# UNITED STATES PATENT AND TRADEMARK OFFICE

APPLICATION NO.	FILING DATE	FIRST NAMED INVENTOR	ATTORNEY DOCKET NO.	CONFIRMATION NO.
10/032,606	10/19/2001	Kevin R. Keegan	89190.072901/DP-304631	8160
7590 04/13/2004 Delphi Technologies, Inc. P.O. Box 5052 Mail Code 480414420 Troy, MI 48007			EXAMINER ALEJANDRO, RAYMOND	
			ART UNIT 1745	PAPER NUMBER

## Office Action Summary

## **DETAILED ACTION**

FIGURE 2

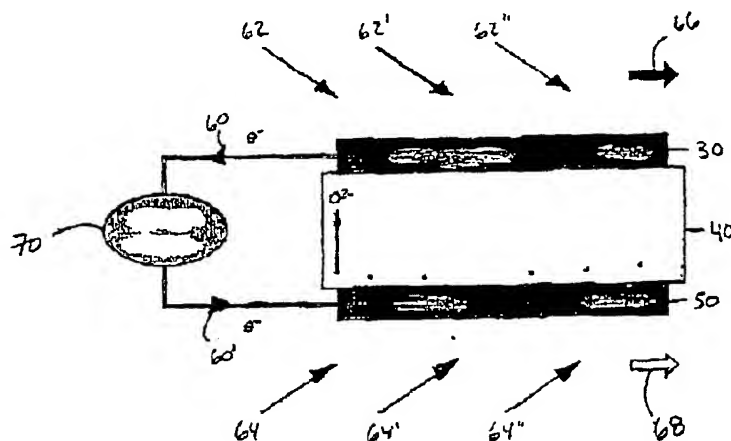
Figure 2 below illustrates an solid oxide electrochemical fuel cell in operation producing a current flow as shown by current flow arrows 60 and 60'. Oxidant gases, such as oxygen or air, can be introduced to the cathode side of the cell, flowing as illustrated by the oxidant flow arrows 64, 64' and 64". The reaction of the fuel and oxide ions, producing electrons (e-), which flow outside of the electrochemical cell 10 to the external circuit 70 and back to the cathode 50 (SECTION 0024). At the anode, the oxide ions react with a fuel, such as hydrogen which as introduced to the electrochemical cell 10 as illustrated by the fuel flow arrows 62, 62' and 62" (SECTION 0025). It is further disclosed that the electrolyte 40 conducts these oxides ions ( $O^{2-}$ ) between the anode 30 and the cathode 50, maintaining an overall electrical charge balance. The cycle of flowing electrons (e-) from the anode 30 through the external circuit 70 to the cathode

50 creates electrical energy for harnessing (SECTION 0027). Mieney et al teach that an end cap 20 includes a surface 22 that is configured for disposal adjacent to the anode 30 to provide fuel distribution; and an interconnect 24 includes a first interconnect surface 26 which is configured adjacent to the cathode 50 to provide oxidant distribution (SECTION 0019). It is also disclosed that oxide ions flow through the electrolyte 40 (SECTION 0029 & 0020). Therefore, considering that anode 30, cathode 50 and the solid electrolyte 40 each has a three dimension structure (volume or 3D), it is contended that fuel and oxidant distribution flow areas represented by reference numerals 66 (the fuel stream arrow), reference numeral 62, 62' and 62'' (the fuel flow arrows), reference numeral 68 (the oxidant stream arrow) and reference numeral 64, 64' and 64'' (the oxidant flow arrows), respectively, are generally **non-parallel and/or orthogonal** (intersecting or lying at right angles or having perpendicular slopes or tangents at the point of intersection) to the flow of oxygen ions ( $O^{2-}$ ) through the electrolyte 40 as illustrated below in Figure 2. In particular, fuel flow arrows 62, 62' and 62'' and oxidant flow arrows 64, 64' and 64'' are non-parallel to the oxygen ions flow; and fuel stream arrow 66 and oxidant stream arrow 68 are orthogonal to the flow of oxygen ions.

**Figure 2** above, in particular, shows fuel stream arrow 66 and oxidant stream arrow 68 which are orthogonal to the flow of oxygen ions.

FIGURE 2

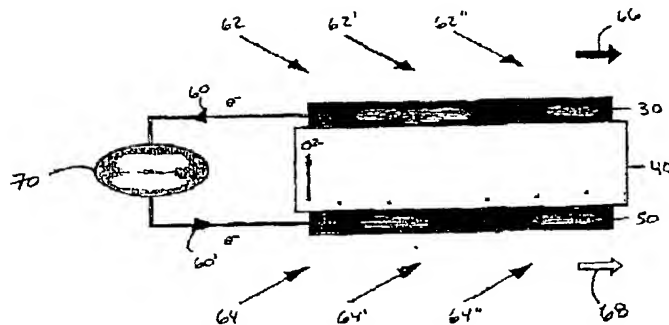
As explained above, **Figure 2** illustrates an solid oxide electrochemical fuel cell in operation producing a current flow as shown by current flow arrows 60 and 60'. Oxidant gases, such as oxygen or air, can be introduced to the cathode side of the cell, flowing as illustrated by the oxidant flow arrows 64, 64' and 64". The reaction of the fuel and oxide ions, producing electrons (e-), which flow outside of the electrochemical cell 10 to the external circuit 70 and back to the cathode 50 (SECTION 0024). At the anode, the oxide ions react with a fuel, such as hydrogen which as introduced to the electrochemical cell 10 as illustrated by the fuel flow arrows 62, 62' and 62" (SECTION 0025). It is further disclosed that the electrolyte 40 conducts these oxides ions ( $O^{2-}$ ) between the anode 30 and the cathode 50, maintaining an overall electrical charge balance. The cycle of flowing electrons (e-) from the anode 30 through the external circuit 70 to the cathode 50 creates electrical energy for harnessing (SECTION 0027). Mieney et al teach that an end cap 20 includes a surface 22 that is configured for disposal adjacent to the anode 30 to provide fuel distribution; and an interconnect 24 includes a first interconnect surface 26 which is configured adjacent to the cathode 50 to provide oxidant distribution (SECTION 0019). It is also disclosed that oxide ions flow through the electrolyte 40 (SECTION 0029 & 0020). Therefore, considering that anode 30, cathode 50 and the solid electrolyte 40 each has a three dimension structure (volume or 3D), it is contended that fuel and oxidant distribution flow areas represented by reference numerals 66 (the fuel stream arrow), reference numeral 62, 62' and 62" (the fuel flow arrows), reference numeral 68 (the oxidant stream arrow) and reference numeral 64, 64' and 64" (the oxidant flow arrows), respectively,

are generally non-parallel and/or orthogonal (intersecting or lying at right angles or having perpendicular slopes or tangents at the point of intersection) to the flow of oxygen ions ( $O^{2-}$ ) through the electrolyte 40 as illustrated below in Figure 2. In particular, fuel flow arrows 62, 62' and 62'' and oxidant flow arrows 64, 64' and 64'' are non-parallel to the oxygen ions flow; and fuel stream arrow 66 and oxidant stream arrow 68 are orthogonal to the flow of oxygen ions.
